UNITED STATES PATENT AND TRADEMARK OFFICE

APPLICATION NO.	FILING DATE	FIRST NAMED INVENTOR	ATTORNEY DOCKET NO.	CONFIRMATION NO.
10/630,210	07/30/2003	Joseph E. Mattingly JR.	AMC.P.US0021	2012
26360	7590	02/21/2006	EXAMINER	
RENNER, KENNER, GREIVE, BOBAK, TAYLOR & WEBER FIRST NATIONAL TOWER FOURTH FLOOR 106 S. MAIN STREET AKRON, OH 44308			COOLEY, CHARLES E	
			ART UNIT	PAPER NUMBER
			1723

Office Action Summary	Application No.	Applicant(s)	
	10/630,210	MATTINGLY, JOSEPH E.	
	Examiner	Art Unit	
	Charles E. Cooley	1723

NON-FINAL OFFICE ACTION

FIG. 2B.

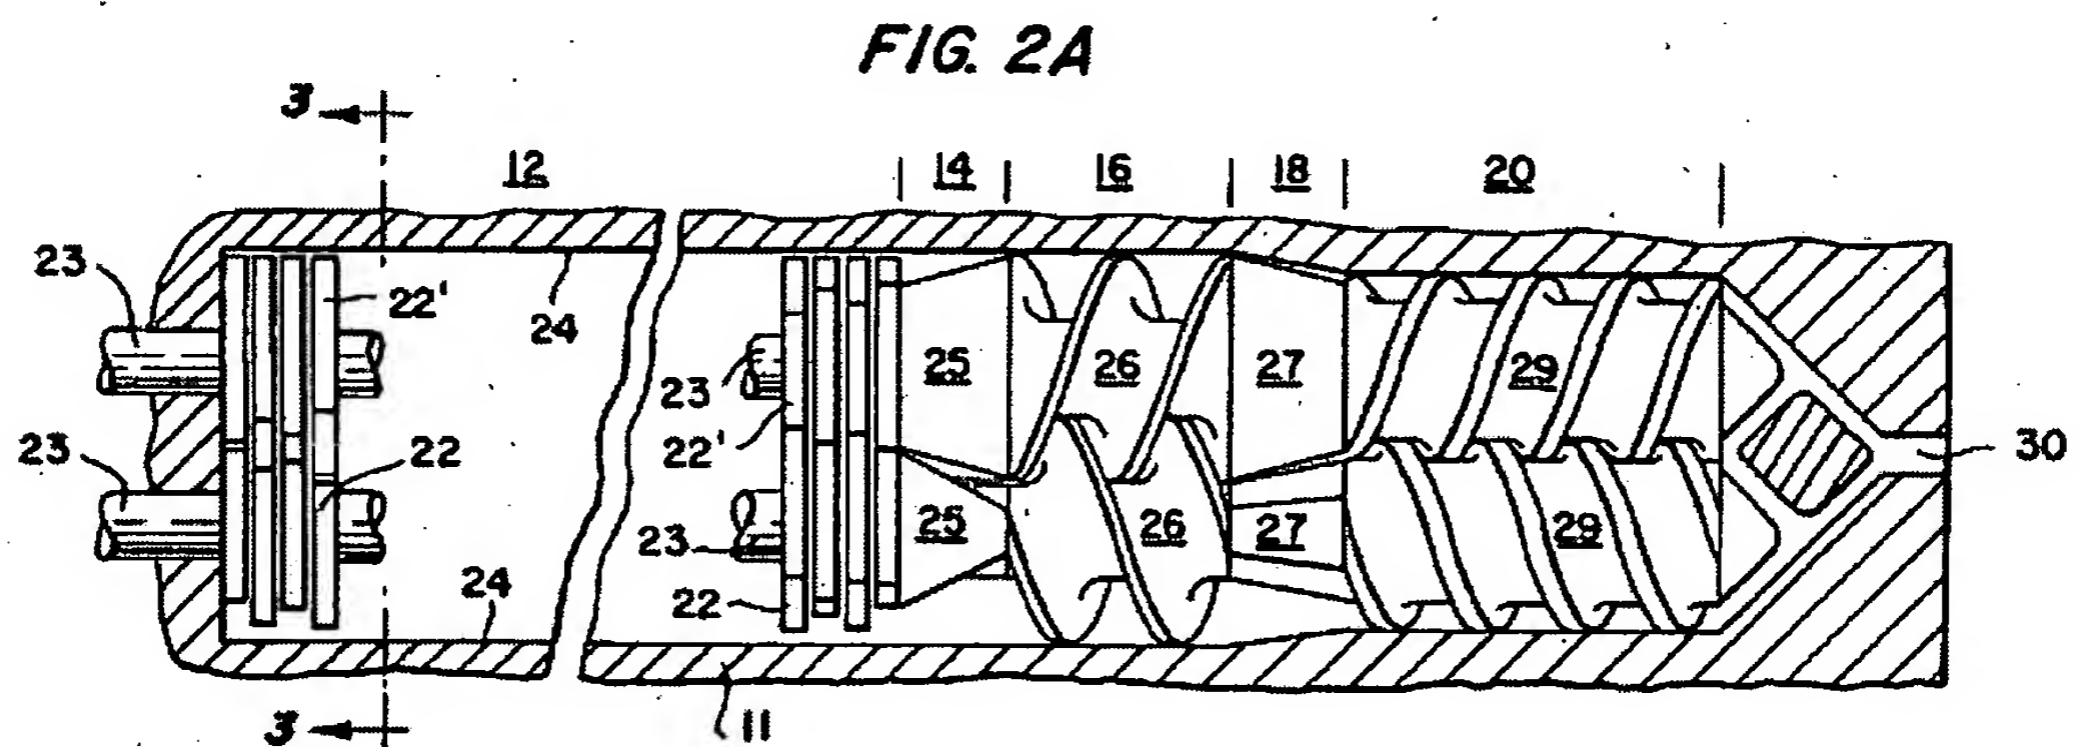
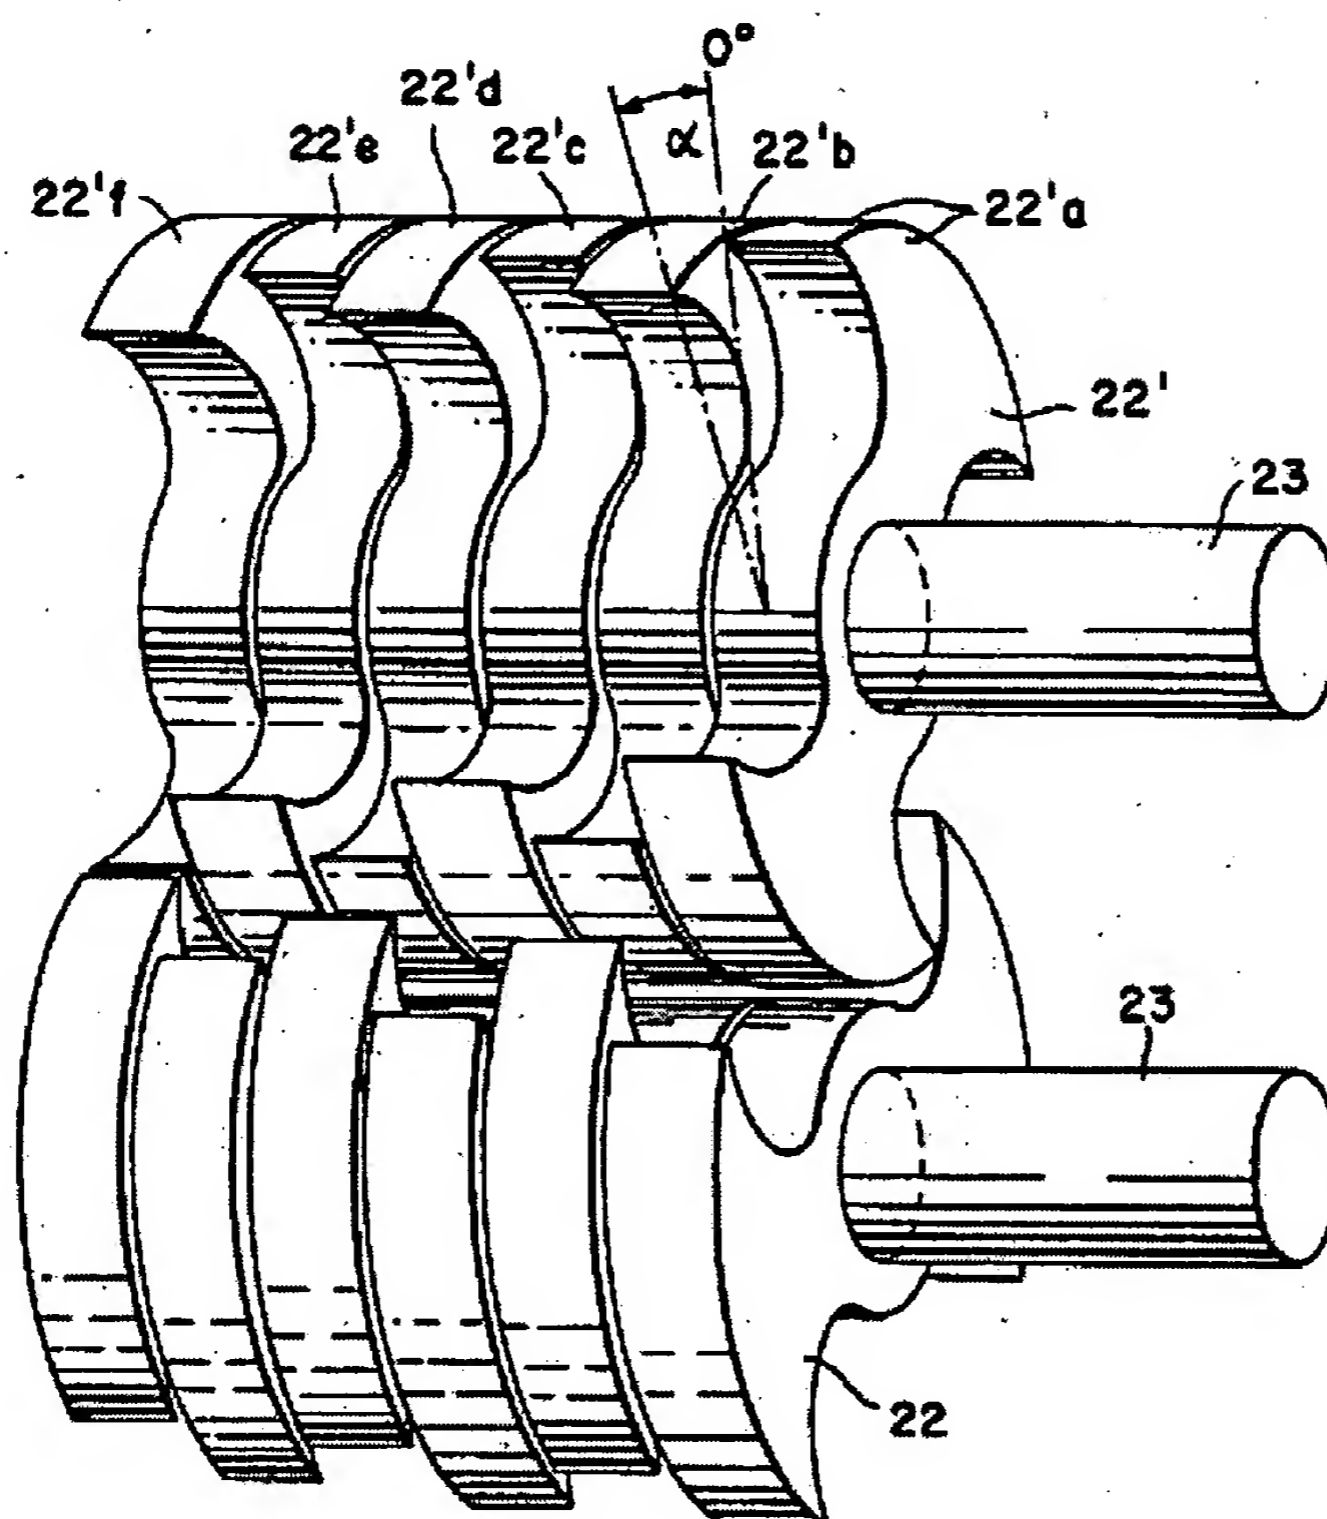
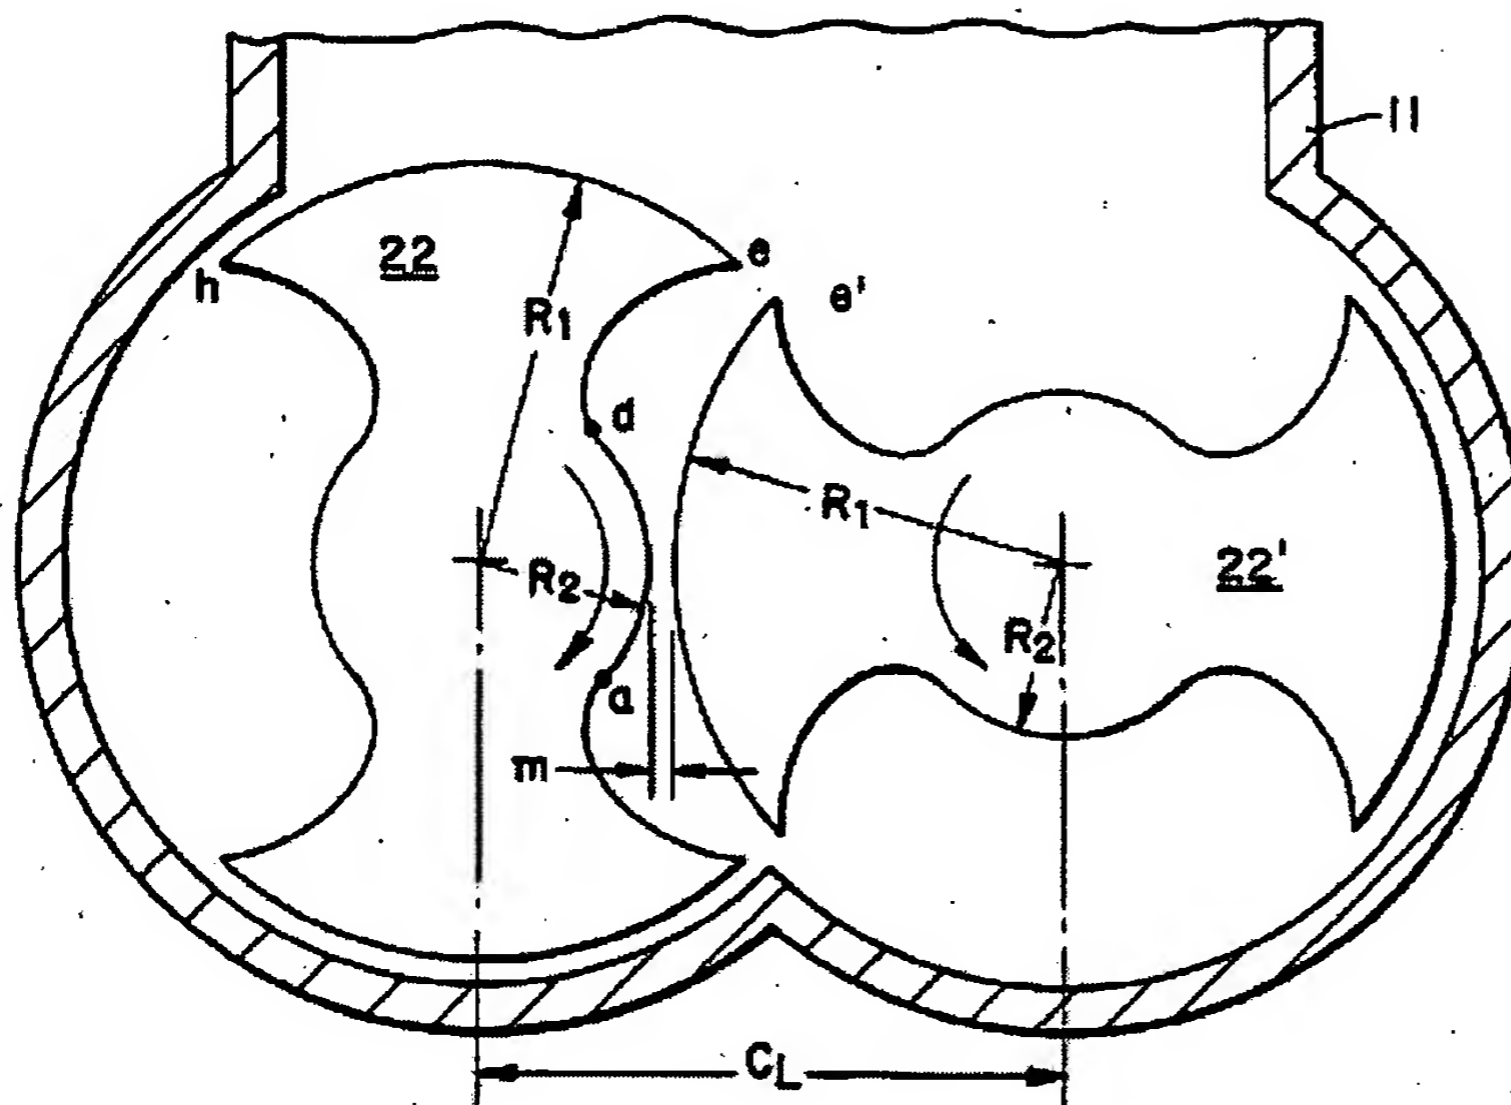
10. Claims 1, 3, 4, 5, 9, 11, 12, 13, 15, 16, 17, 18, and 19 are rejected under 35 U.S.C. 102(b) as being anticipated by Tynan (US 4,556,324).

The patent to Tynan discloses an element (one or more of members 22 or 22') as seen in the Figures below comprising one or more lobes extending from a central portion adapted to receive a shaft 23; wherein the one or more lobes has an outer periphery ridge and first and second lateral sidewalls, wherein one of said lateral

sidewalls of said at least one lobe is concave between said outer periphery ridge and said central portion (as seen in the Figures); wherein the other of said lateral sidewalls on each lobe is concave between said first outer periphery ridge and said central portion (as seen in the Figures); the element may comprise one or more of members 22 or 22' and includes two or three or more lobes as seen in Figs. 2A and 2B; the element constituting a block comprising a plurality of elements (multiple members 22 or 22'), wherein the block includes at least two kneading elements 22 or 22' wherein one of the lateral sidewalls on at least one lobe is concave between said outer periphery ridge and said central portion; wherein the block comprises N number of kneading elements 22 or 22' adjacent to each other (e.g., N number of 22 or 22' - Fig. 2B), wherein all the elements have at least one lobe having first and second lateral sidewalls and wherein one of the lateral sidewalls on said at least one lobe is concave between said outer periphery ridge and said central portion; wherein at least the first element (an upstream member 22 or 22') of the block has at least one lobe having first and second lateral sidewalls and wherein one of the lateral sidewalls on said at least one lobe is concave between said outer periphery ridge and said central portion; wherein at least the last element (a downstream member 22 or 22') of the block has at least one lobe having first and second lateral sidewalls and wherein one of the lateral sidewalls on said at least one lobe is concave between said outer periphery ridge and said central portion; wherein at least the first and last elements (an upstream member 22 or 22' and a downstream member 22 or 22') of the block has at least one lobe having first and second lateral sidewalls and wherein one of the lateral sidewalls on said at least one

lobe is concave between said outer periphery ridge and said central portion; wherein the other of said lateral sidewalls on each lobe in the block is concave between said first outer periphery ridge and said central portion (as seen in the Figures).

【~~図~~1】

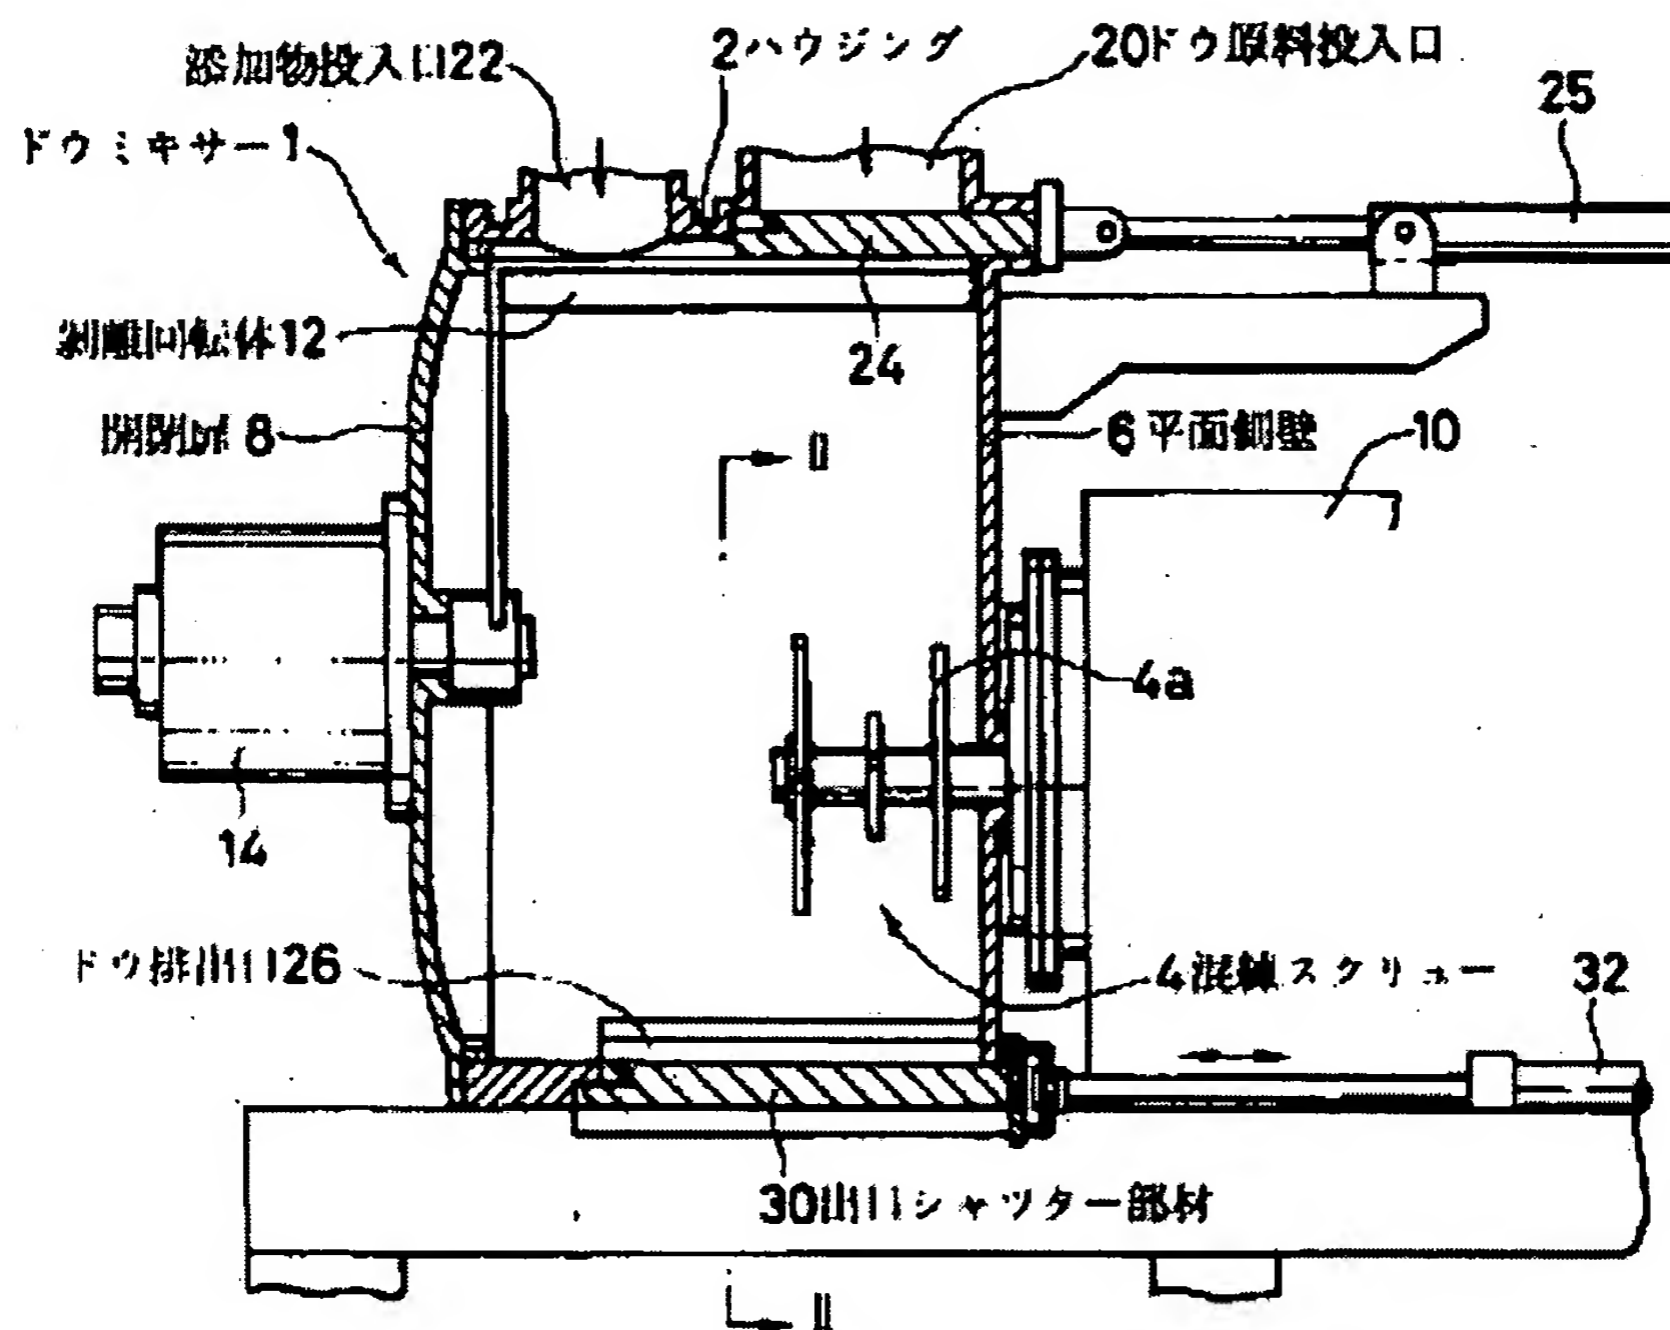
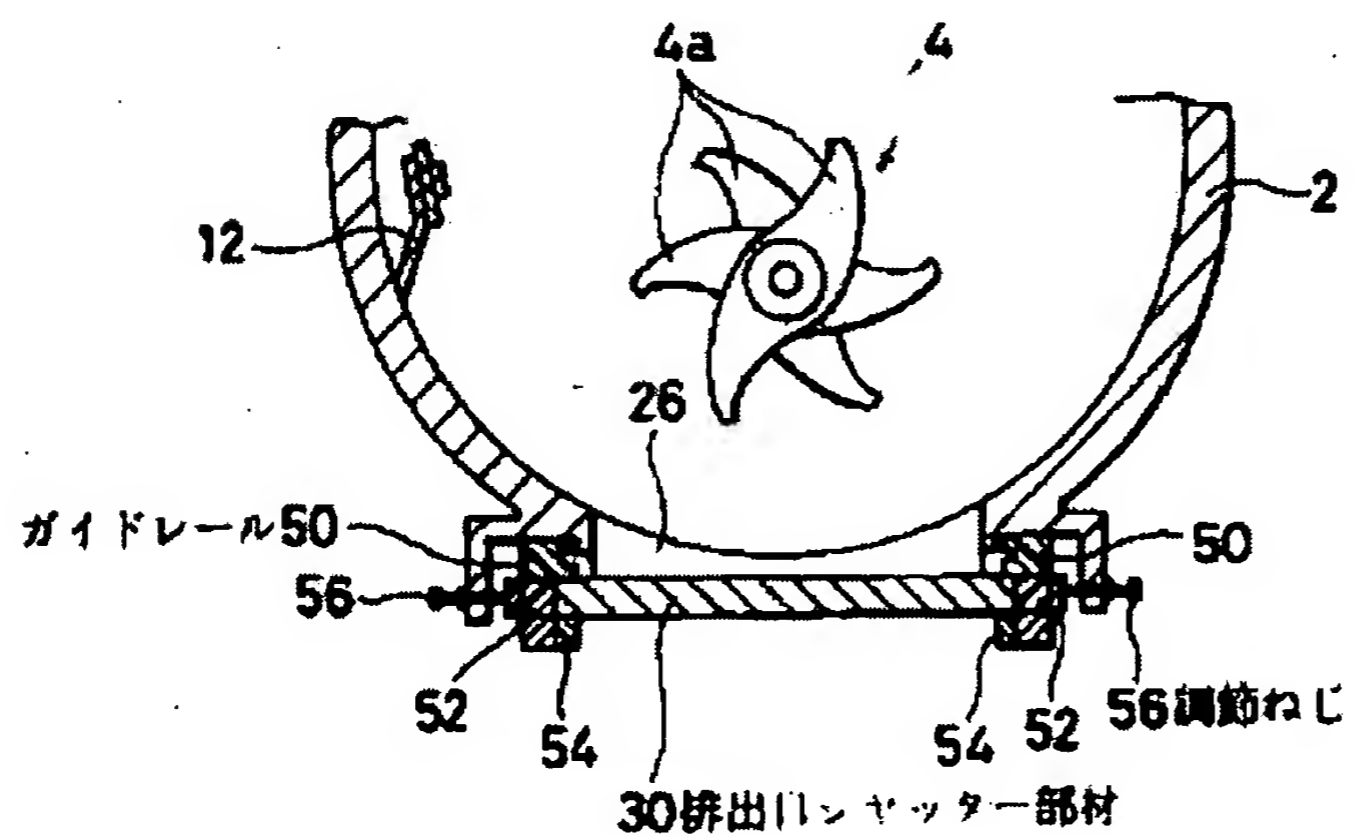
11. Claims 1, 2, 4, 5, 9, 10, 12, 13, 15, 16, 17, 18, and 19 are rejected under 35 U.S.C. 102(b) as being anticipated by JP 6-90651.

JP 6-90651 discloses an element (one or more of members 4a) as seen in the Figures below comprising one or more lobes extending from a central portion adapted to receive a shaft; wherein the one or more lobes has an outer periphery ridge and first and second lateral sidewalls, wherein one of said lateral sidewalls of said at least one lobe is concave between said outer periphery ridge and said central portion (as seen in the Figures); wherein the other of said lateral sidewalls on each lobe is convex between said first outer periphery ridge and said central portion (as seen in the Figures); the element may comprise one or more of members 4a and thus includes two or three or

more lobes as seen in Figs. 1-2; the element constituting a block comprising a plurality of elements (multiple members 4a), wherein the block includes at least two kneading elements 4a wherein one of the lateral sidewalls on at least one lobe is concave between said outer periphery ridge and said central portion; wherein the block comprises N number of kneading elements 4a adjacent to each other (e.g., N number of 4a - Fig. 2), wherein all the elements have at least one lobe having first and second lateral sidewalls and wherein one of the lateral sidewalls on said at least one lobe is concave between said outer periphery ridge and said central portion; wherein at least the first element (an upstream member 4a) of the block has at least one lobe having first and second lateral sidewalls and wherein one of the lateral sidewalls on said at least one lobe is concave between said outer periphery ridge and said central portion; wherein at least the last element (a downstream member 4a) of the block has at least one lobe having first and second lateral sidewalls and wherein one of the lateral sidewalls on said at least one lobe is concave between said outer periphery ridge and said central portion; wherein at least the first and last elements (an upstream member 4a and a downstream member 4a) of the block has at least one lobe having first and second lateral sidewalls and wherein one of the lateral sidewalls on said at least one lobe is concave between said outer periphery ridge and said central portion; wherein the other of said lateral sidewalls on each lobe in the block is convex between said first outer periphery ridge and said central portion (as seen in the Figures).
